**ADDENDUM NO. 1
FEBRUARY 26TH, 2026**

PROJECT: ANSON ISD
ELEMENTARY & HIGH SCHOOL CLASSROOM ADDITION

BID DATE: MARCH 5TH, 2026

SCALE: 3/4" = 1'-0"

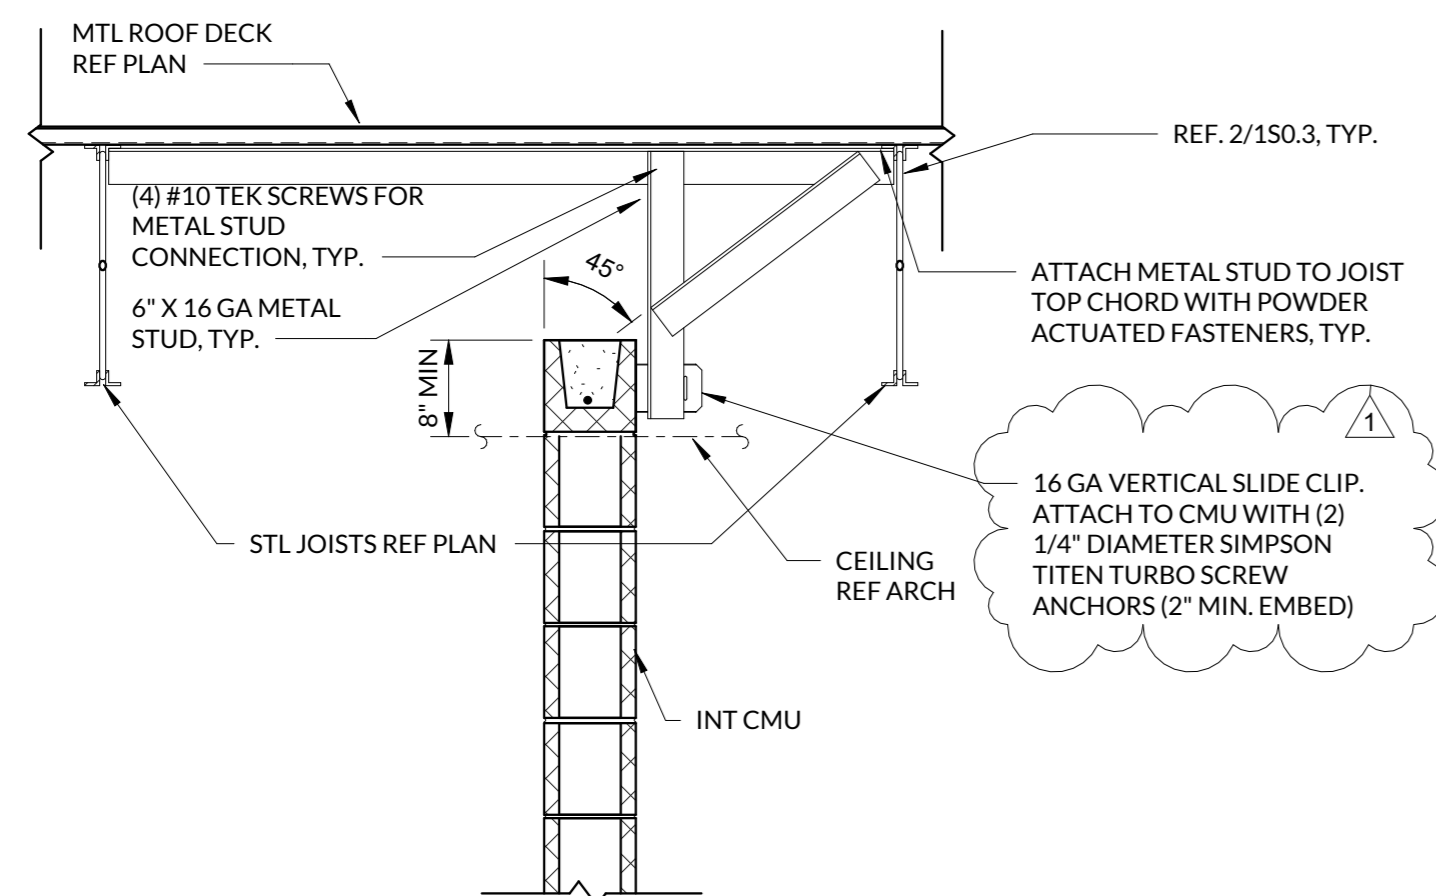
- Item #D5** **Sheet 1S2.0** – REPLACE sheet with attached sheet 1S2.0 dated 02-26-2026. REVISED bottom of deck elevations.
- Item #D6** **Sheet 1S4.0** – REPLACE sheet with attached sheet 1S4.0 dated 02-26-2026. REVISED framing details.

ANSON ISD
 ELEMENTARY SCHOOL CLASSROOM ADDITION
 ELECTRICAL POWER PLAN

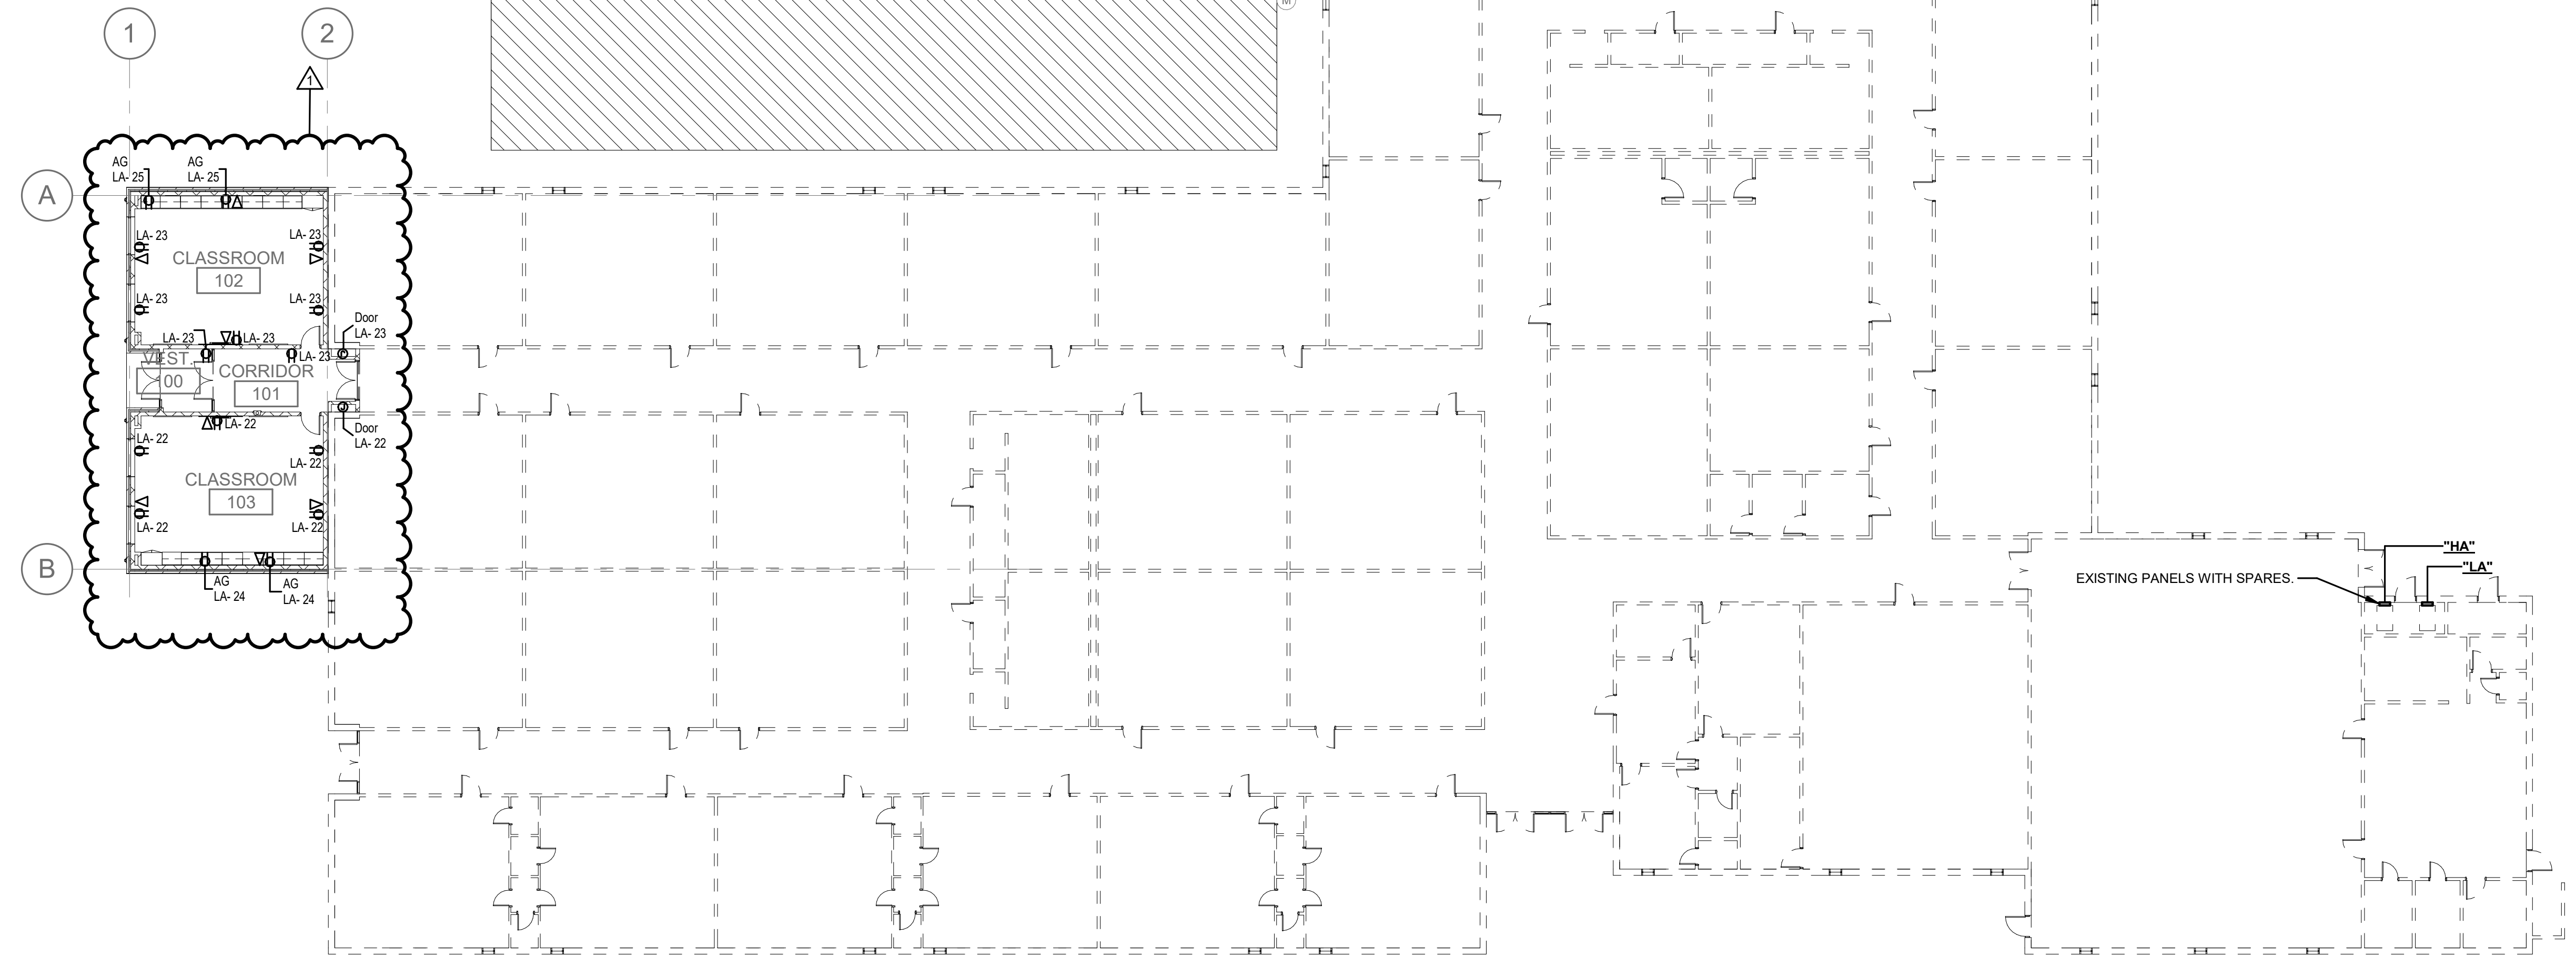
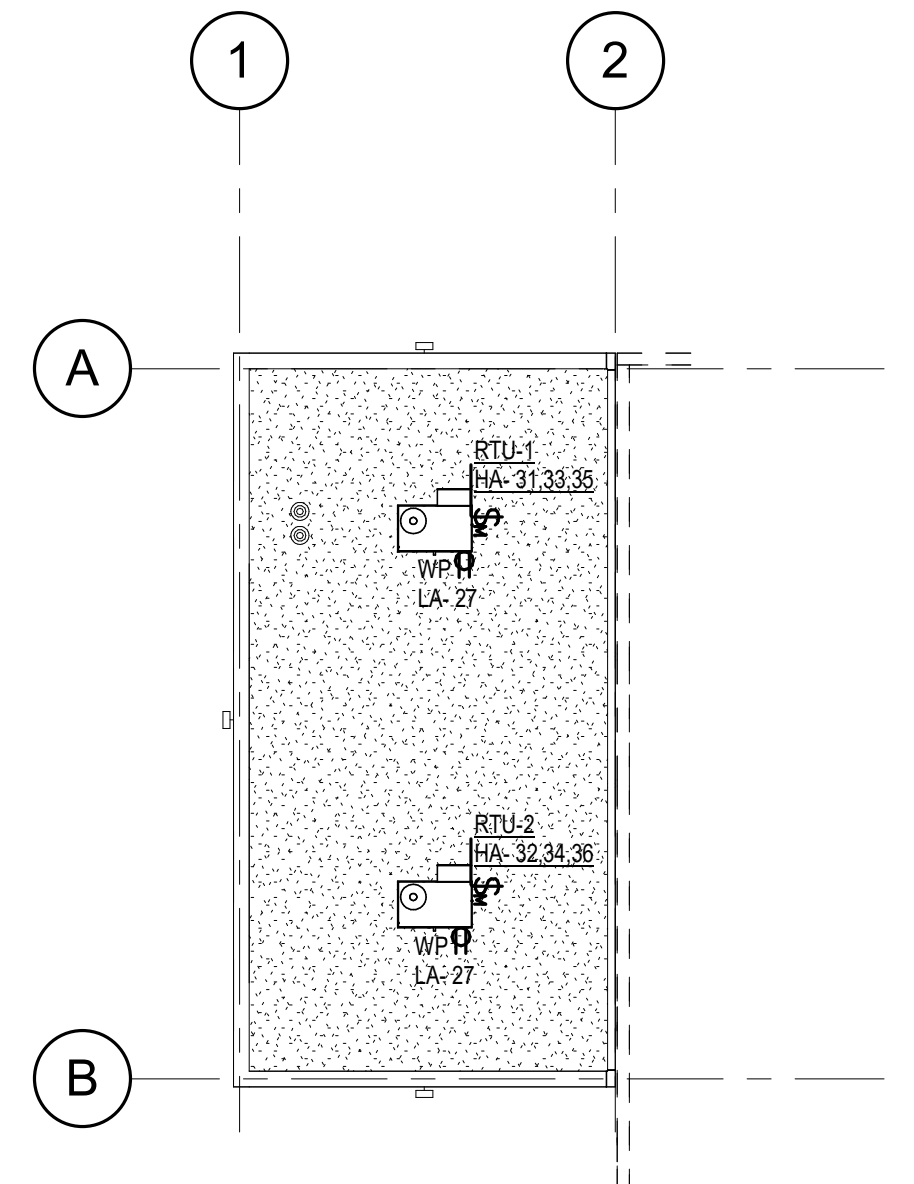
- Item #D7** **Sheet 1E1.0** – REPLACE sheet with attached sheet 1E1.0 dated 02-26-2026. UPDATED power plan to add more data locations.
- Item #D8** **Sheet 1E2.0** – REPLACE sheet with attached sheet 1E2.0 dated 02-26-2026. UPDATED reflected ceiling plan with updated lighting layout in Vest. 106. UPDATED lighting fixture schedule.
